Amended Final EIA Report

14/12/16/3/3/2/533

Short name: ANJUTONE 2 SOLAR PARK

Commissioned by: Anjutone (Pty) Ltd
Document version 3.0 – Amended Final

Figure 9 Other renewable energy projects in the proximity of the proposed Anjutone 2 Solar Park

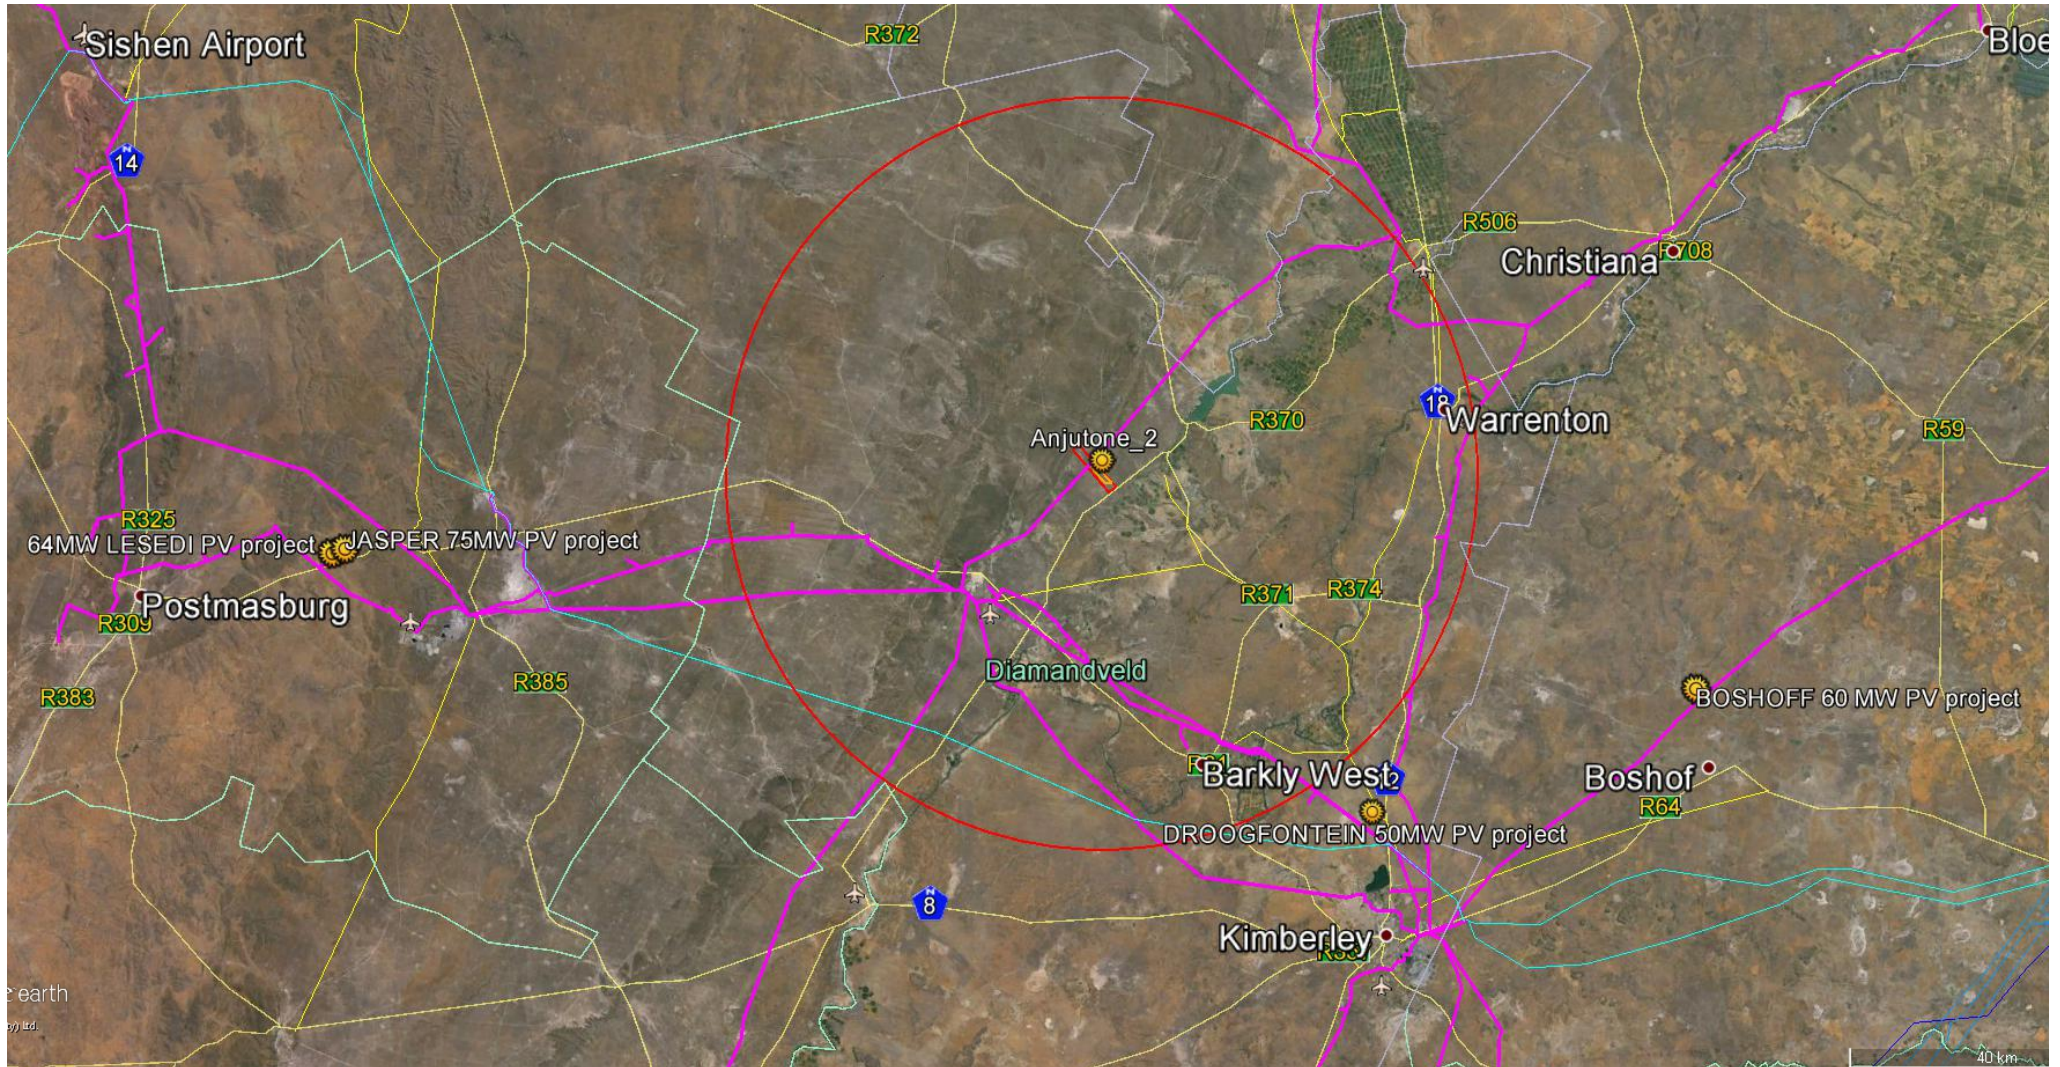
b) [DEA] The amended EIAR must provide a final wetland delineation study as the Final EIAR contains a draft wetland study. The recommendations and mitigation measures of the abovementioned study must be included into the amended EIAR and draft Environmental Management Programme.

The new paragraph **6.2. OTHER RENEWABLE ENERGY PROJECTS IN THE PROXIMITY OF THE PROPOSED ANJUTONE 2 SOLAR PARK** has been added, as well a map indicating the renewable energy projects in the proximity of the proposed Anjutone 2 Solar Park (Figure 9).

As explained in the paragraph 6.2, **the cumulative impact is NOT APPLICABLE**, because there are no renewable energy projects currently planned and selected by the Department of Energy in the proximity (< 50 km) of the proposed PV project. The closer project under construction is the Mainstream Droogfontein 48 MW PV project, located at **60 km** from the proposed solar park.
